# **Response to Michigan Department of Environmental Quality Comments dated May 9, 2016 on the Back Forty Project Mine Permit Application**

**Project I.D.: 14A021**

**Aquila Resources Inc.  
Stephenson, Michigan**

**June 2016**

**FIGURE 1-1**  
 MINING PERMIT APPLICATION  
 OVERALL PROJECT TIMELINE  
 STEPHENSON, MICHIGAN

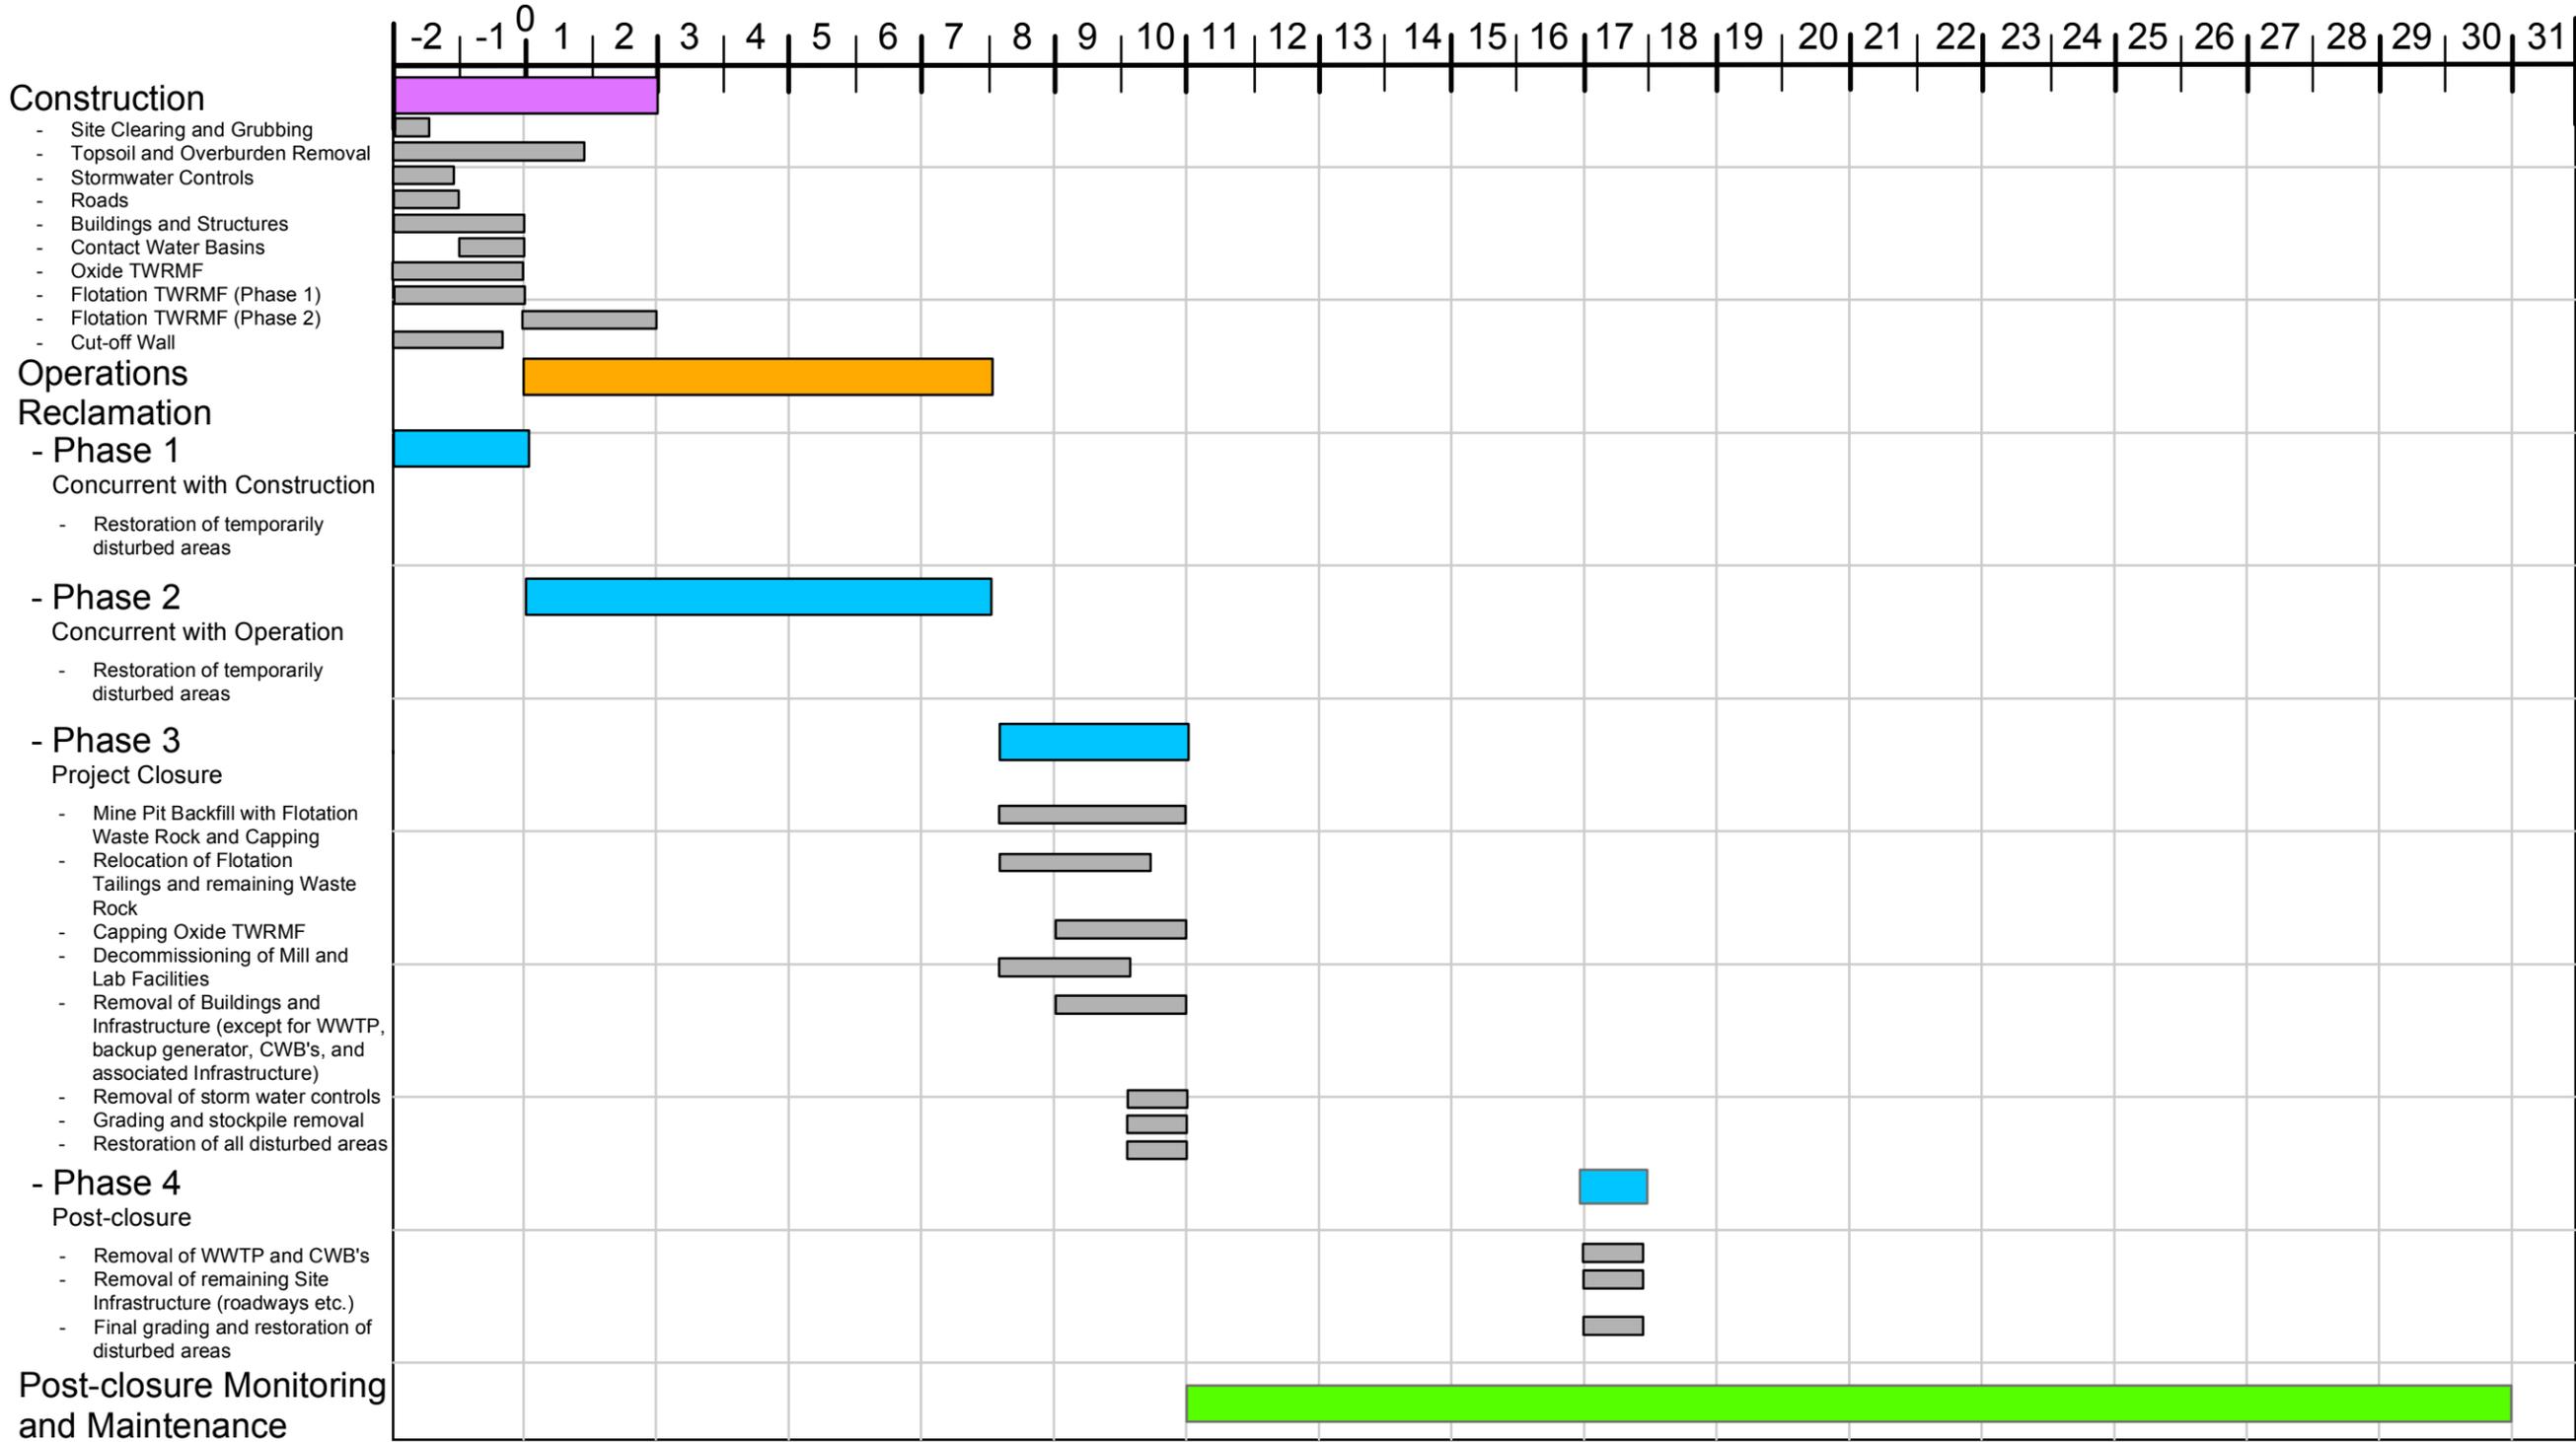
*Figure 2-2, Volume I: Overall Project Timeline: When will the construction of the cutoff wall take place?*

Construction for the cut-off wall will be in mine year -02. New Figure 1-1 provided in Attachment 1 has been revised to show the cut-off wall construction event.

BACK FORTY PROJECT			
FIGURE 19-1			
MINING PERMIT APPLICATION			
FINAL PIT PLAN			
Scale:	AS SHOWN	Date:	MAY 2016
Drafted By:	MRS	Project No.:	14A021

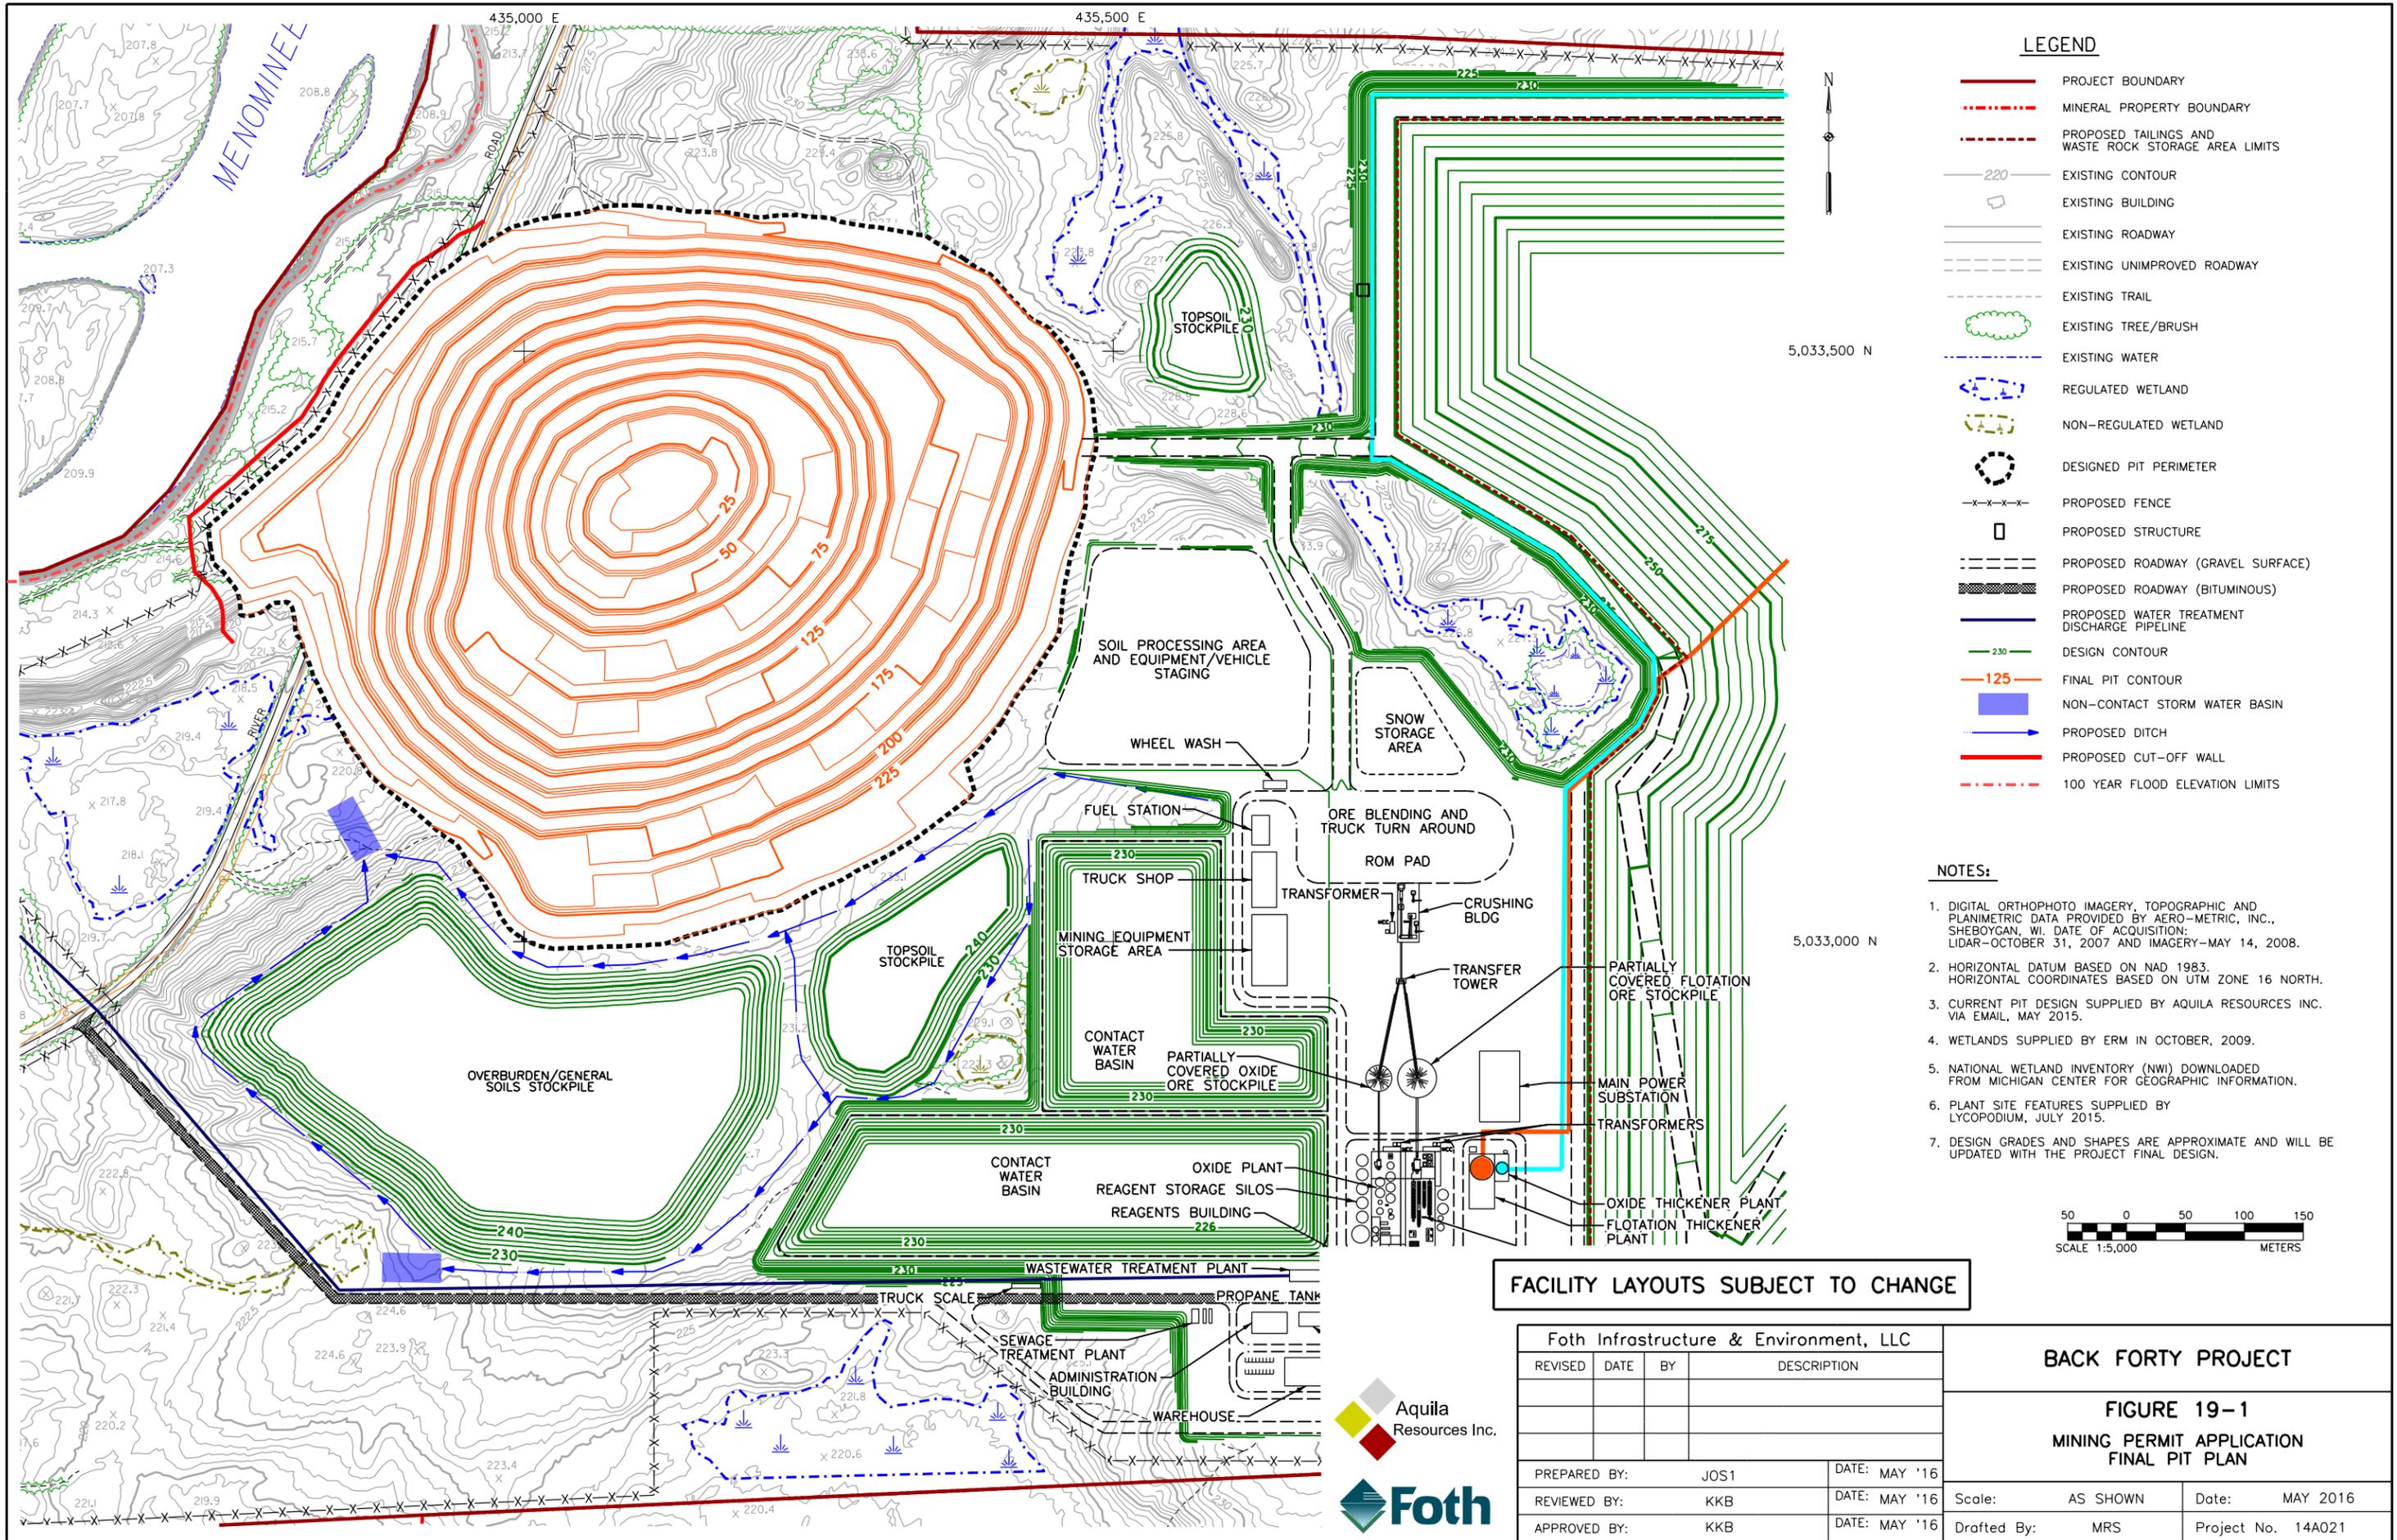
*Figure 5-1: Explain the “Topsoil Stockpile” labelled on the Menominee River.*

New Figure 19-1 in Attachment 19 has been revised removing the “Topsoil Stockpile” reference in the Menominee River. In addition, the 18 meter setback reference from the Menominee River

BACK FORTY PROJECT	
<b>FIGURE 28-1</b>	
SITE LOCATION PLAN SHOWING OPEN PIT AND CUT-OFF WALL ALIGNMENT STEPHENSON, MICHIGAN	
Scale:  1:4,000 Meters	Date: JUNE 2016
Drafted by: DAT	Project No: 14A021

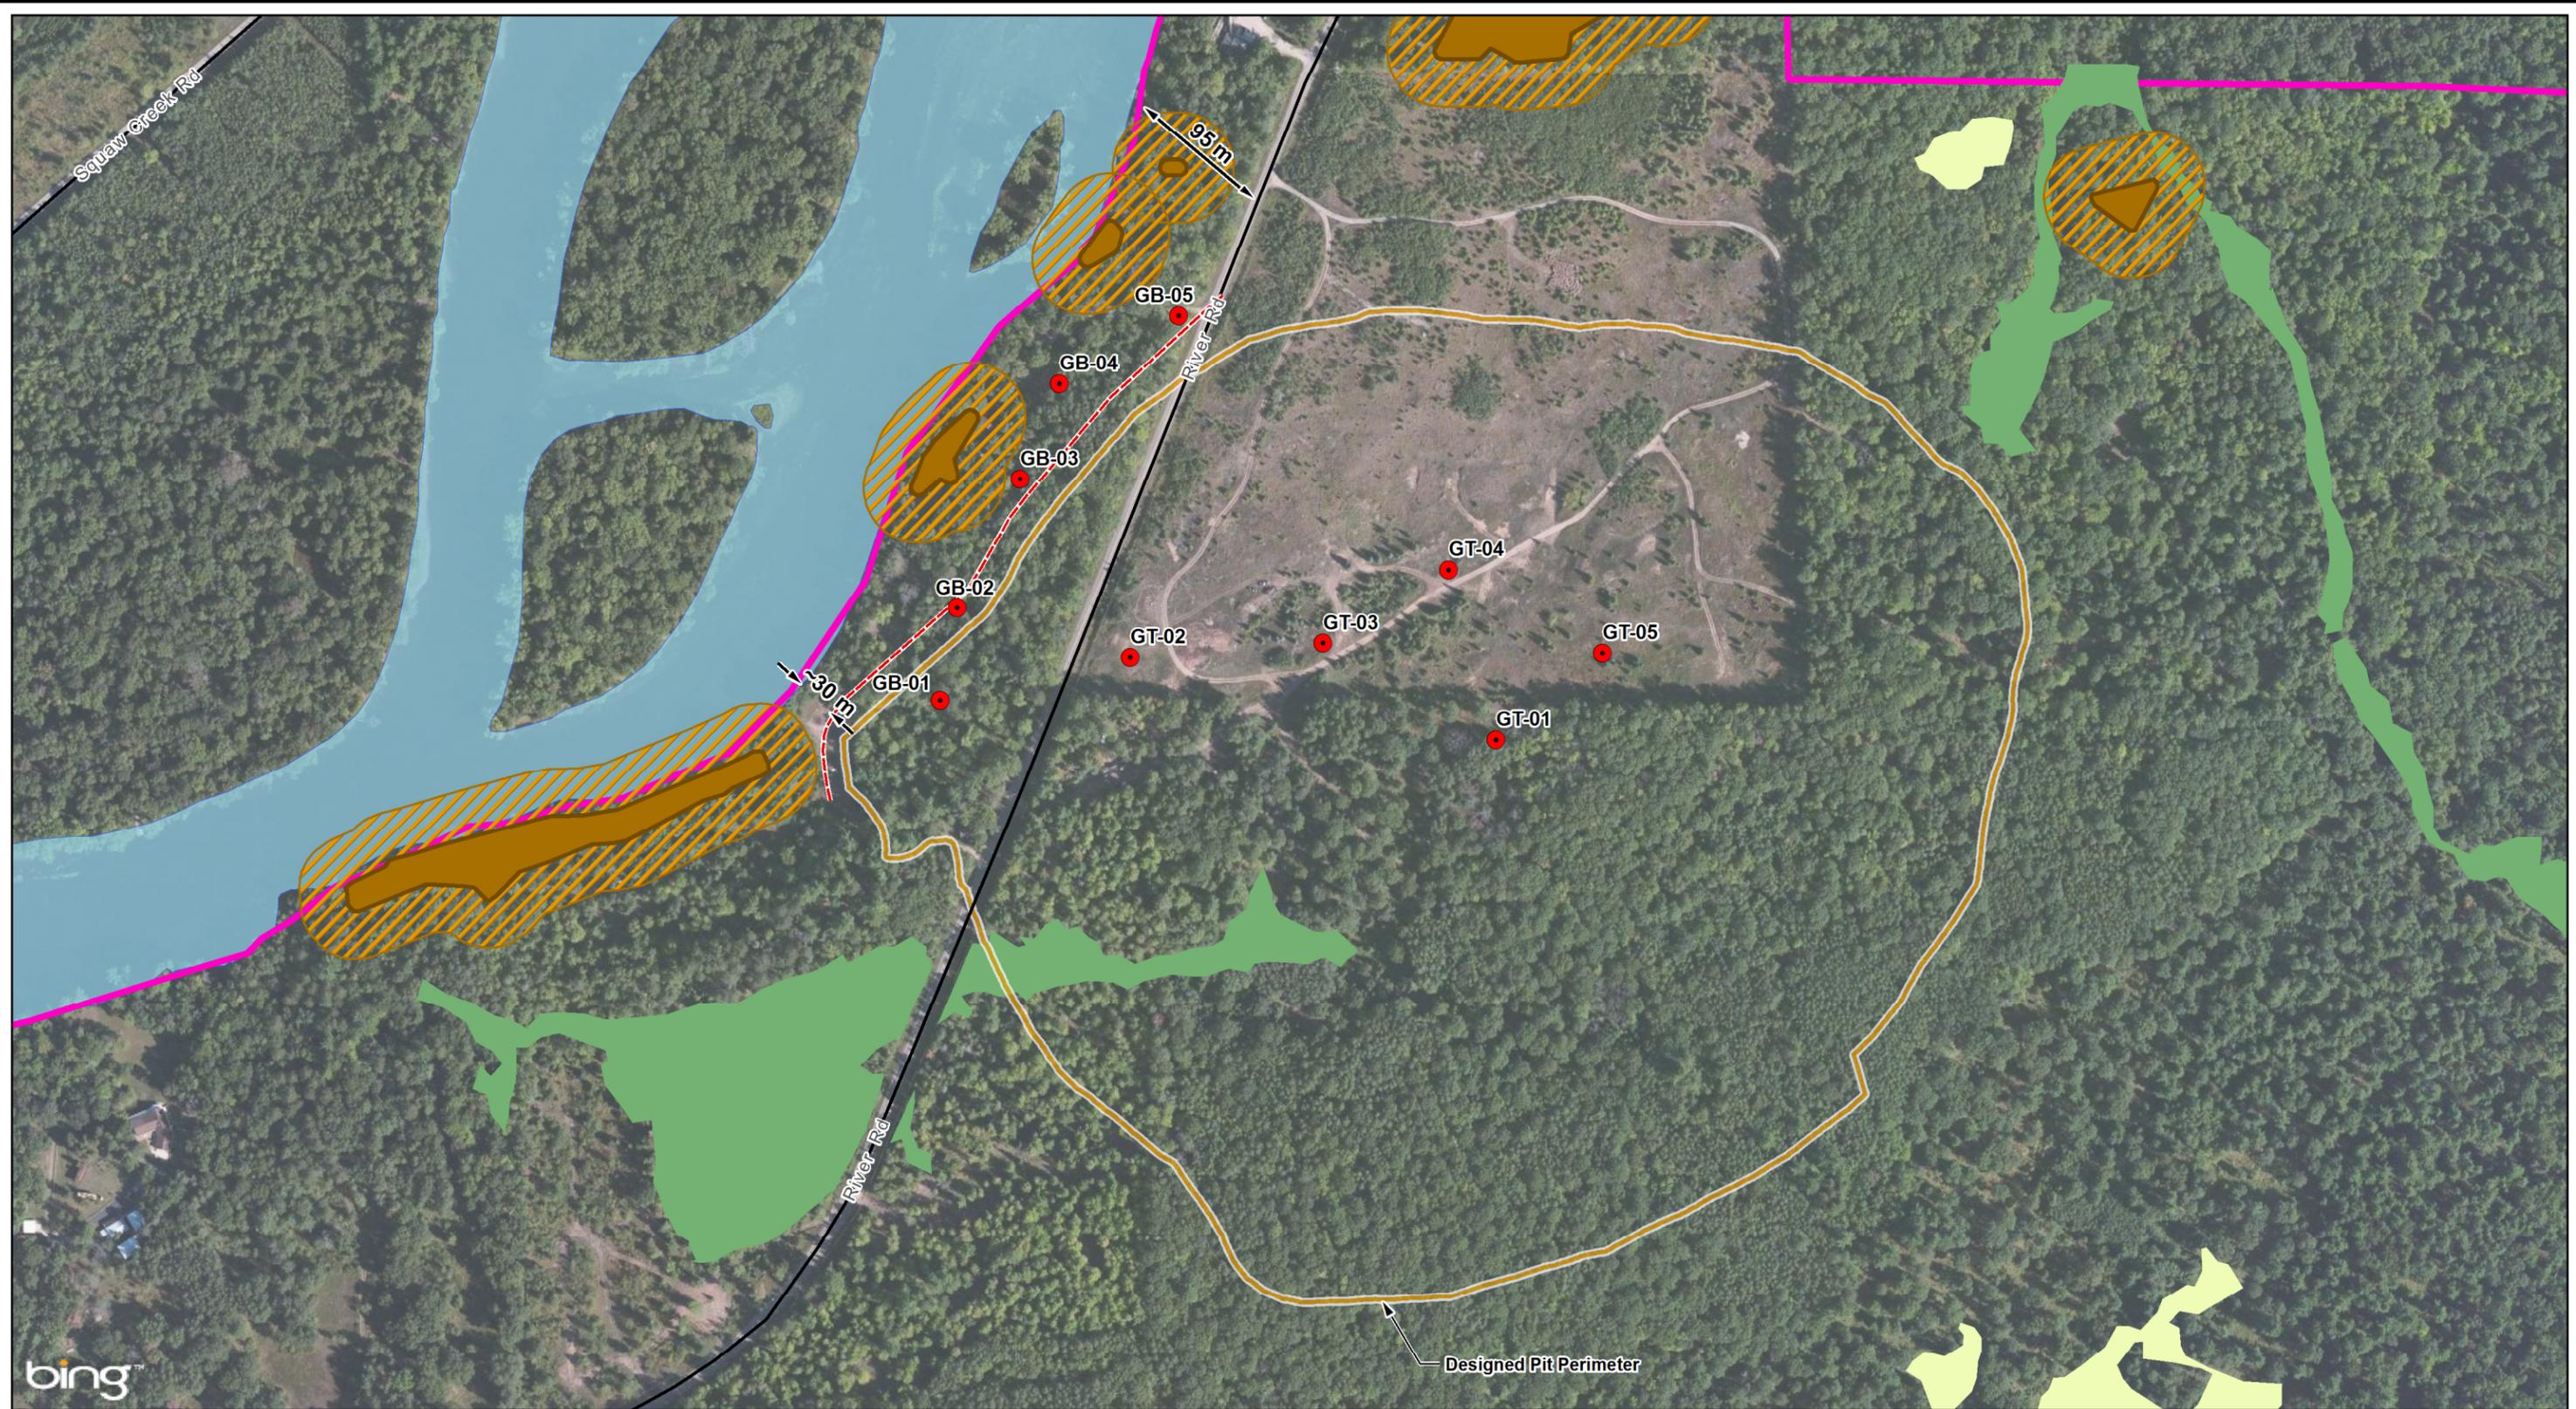
*Figure 1 – distance shown on the map on the west side of pit shows cutoff wall 28 meters from river. Explain how this meets the proposed cutoff wall setback of 100 feet from the river ordinary high water mark.*

The distance shown on Figure 28-1, located in Attachment 28, has been revised to show the setback distance of 30 meters. Final setback distance will be established during final design and construction and will incorporate all setback requirements.
